## RESPONSE TO REQUEST FOR ADDITIONAL INFORMATION

### APR1400 Design Certification

Docket No. 52-046

RAI No.: 470-8552  
SRP Section: 16 – Technical Specifications  
Application Section: 16.3.3.1  
Date of RAI Issue: 04/26/2016

Figure 7.2-11 **PPS** Testing Overlap

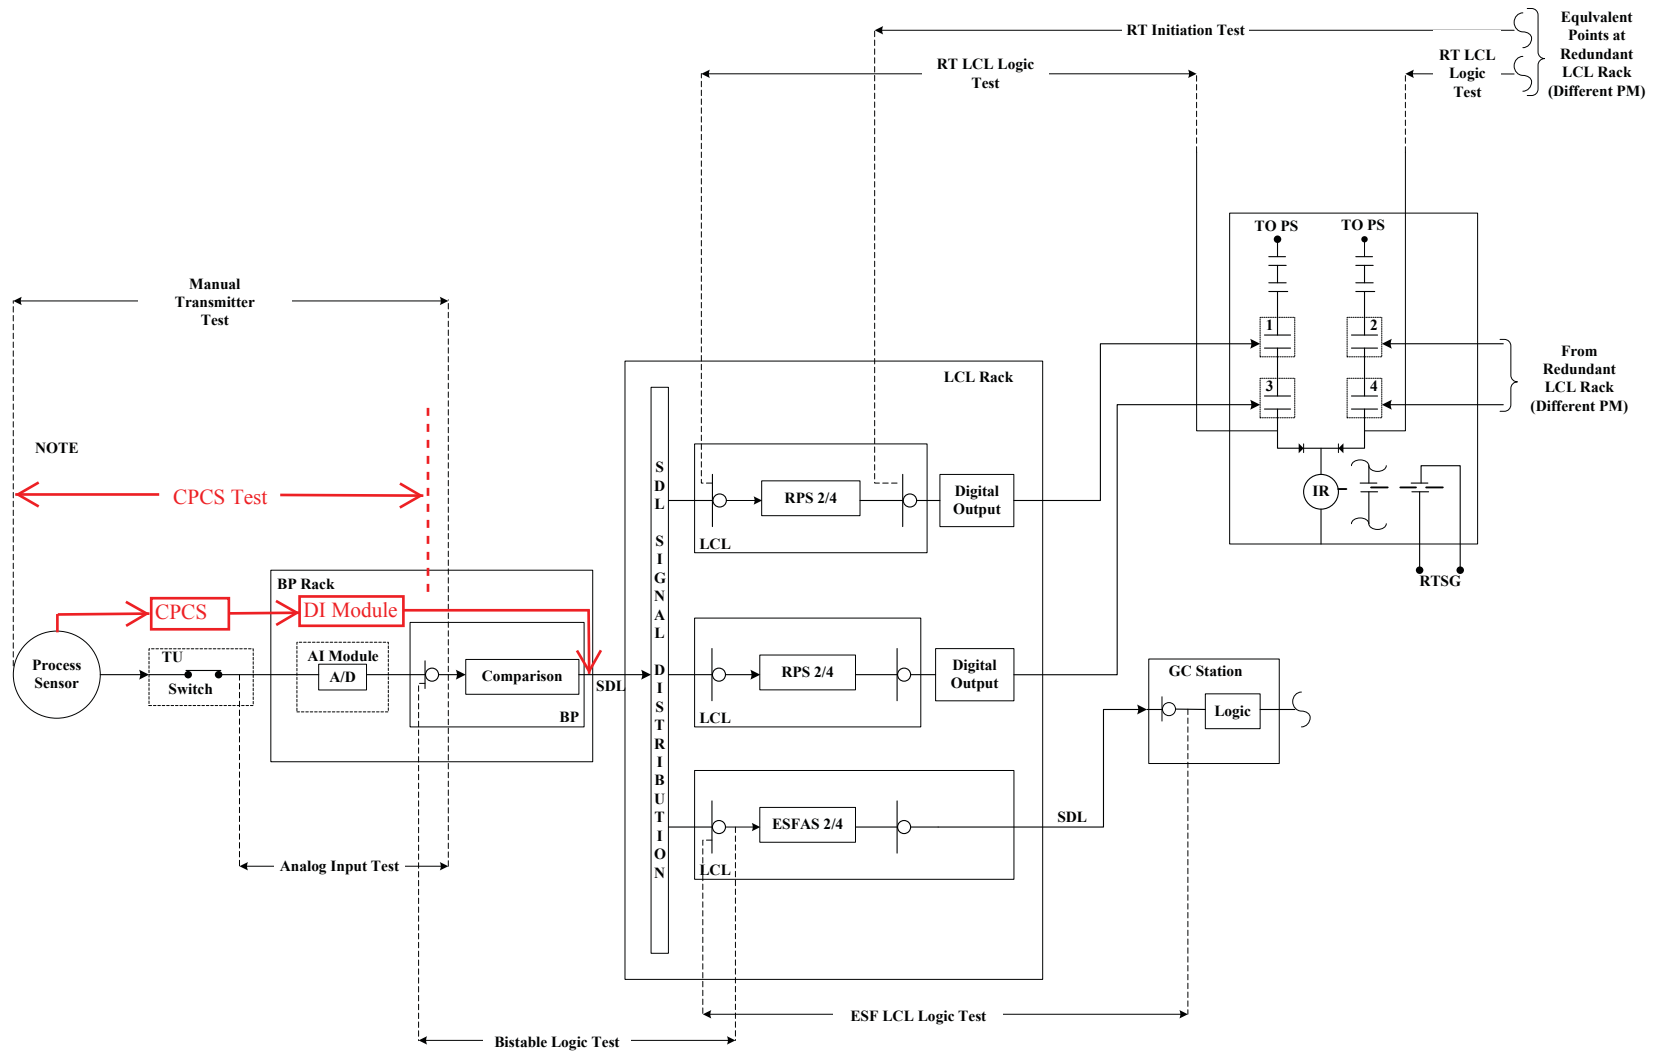
2. Notice that DCD Figure 7.2-11 does not depict "CPCS Test" and "Manual Trip Test", which are described in DCD Section 7.2.2.5. The applicant is requested to revise DCD Tier 2 Section 7.2 so that Section 7.2.2.5 and Figure 7.2-11 are correctly aligned. In addition, consider adding a discussion in DCD Tier 2 Section 7.3 that describes the testing for the ESFAS instrumentation loops with the same level of detail as the requested revised description in DCD Tier 2 Section 7.2.2.5, and also a figure equivalent to Figure 7.2-11. Notice that Figure 7.2-11 depicts no tests for ESFAS related components after the input to the actuation logic in the group controller.

4. The applicant is requested to explain what meaning the "OR" logical gate symbols on Figure 7.2-11 are intended to convey; especially with respect to depicting testing overlap. The requested information is needed to enable the NRC staff to determine whether or not surveillances for RPS and ESFAS instrumentation functions satisfy 10 CFR 50.36 requirements.

1. Table 1 is prepared based on DCD Tier 2 Figure 7.2-11, which shows the testing overlap for the periodic manual tests required to verify the integrity of the RPS functions during power operation of the plant. The component names and descriptions in the figure are identified by relationship with the testing type provided in DCD Tier 2 Section 7.2.2.5, "System Testing and Inoperable Surveillance". Additionally, the "CPCS" and "CPCS test" will be included in DCD Tier 2 Figure 7.2-11.

2. The missing information of CPCS and CPCS Test in DCD Tier 2 Figure 7.2-11 will be added.

4. The logical OR in the receiving stage of bistable processor (BP) indicates that BP logic is processed either by the actual signal or by the test signal. The logical OR in the receiving stage of LCL indicates that local coincidence logic (LCL) logic is processed either by the actual signal or by the test signal.

The logical OR in the transmitting stage of LCL or the receiving stage of the digital output module indicates that the digital output module generates the output either by the actual signal or by the test signal.
